Front Spring Breakage VAH

SP 721-005, Front Spring Breakage

(October 2013)

W7084034

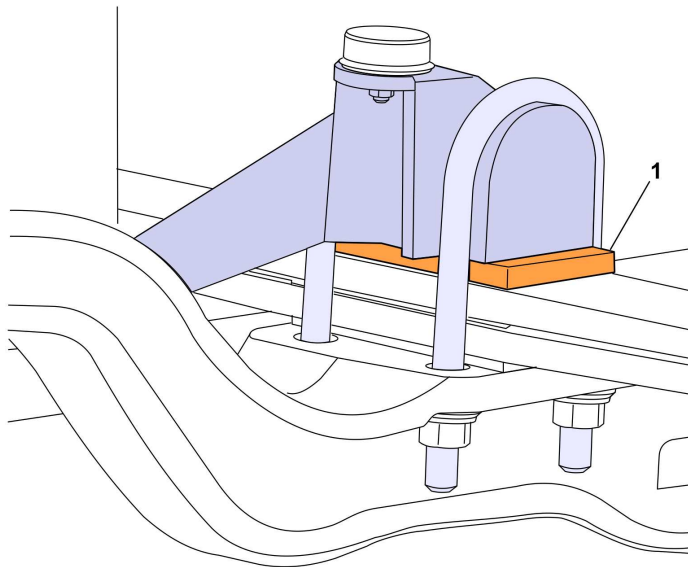
It has been discovered on some VAH vehicles that the front springs can over travel. Over time this can lead to breakage of the spring leaf. A spacer plate will be installed to increase the height of the suspension bumpstops to limit spring travel.

- 1 Spacer to be added between top plate and leaf spring.
 - 7 Remove the top plate over the spring assembly.
 - 8 Install the new spacer onto the spring assembly.
 - 9 Install the top plate, new U-bolts and nuts and secure. Torque to 550 ± 25 Nm (406 ± 18 ft-lb).
- Note:** Tighten evenly in an X - pattern.
- 10 Install the lower shock mounting fastener. Torque to 415 ± 40 Nm (306 ± 30 ft-lb).
 - 11 Perform these same steps on the other side of the vehicle.
 - 12 Jack the steer axle up and remove jack stands and let axle down.
 - 13 Remove wheel chocks.
 - 14 Lower hood.
